# PIC32MZ EF FAMILY

## PIC32MZ Embedded Connectivity with Floating Point Unit (EF) Family Silicon Errata and Data Sheet Clarification

The PIC32MZ Embedded Connectivity with Floating Point Unit (EF) family of devices that you have received conform functionally to the current Device Data Sheet (DS60001320F), except for the anomalies described in this document.

**FIGURE 1: Posc CRYSTAL CIRCUIT**

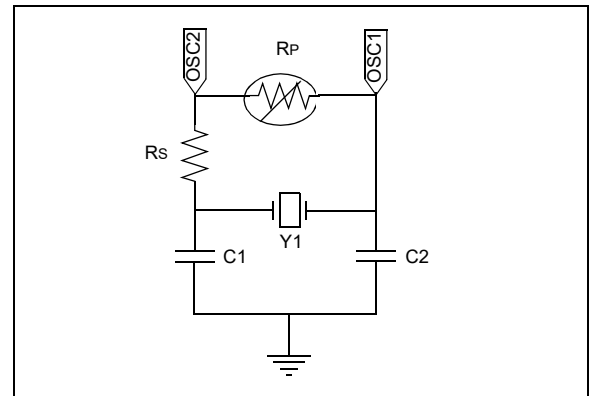
**Revision A3 and B2 Silicon:** The Posc has been tested in a normal power-up sequence and supports specific crystal operation.

The Primary Oscillator (Posc) has been characterized to operate at 8 MHz, 12 MHz, and 24 MHz when the circuit in [Figure 1](#) is implemented, and the operating conditions listed in [Table 3](#) are met.

**Note 1:** Using any other crystal frequency will require special component selection and characterization.  
**Note 2:** A parallel resistor (Rp) should not be used to increase the gain of the POSC.

Crystal Frequency (see Note 1)	Series Resistor (Rs)	Posc Gain Setting POSCGAIN<1:0> (DEVCFG0<20:19>)	Posc Boost Setting POSCBOOST (DEVCFG0<21>)
8 MHz	2 kΩ	'0b00 (GAIN_0)	'0b1 (ON)
12 MHz	1 kΩ	'0b00 (GAIN_0)	'0b1 (ON)
24 MHz	0 kΩ	'0b00 (GAIN_0)	'0b1 (ON)
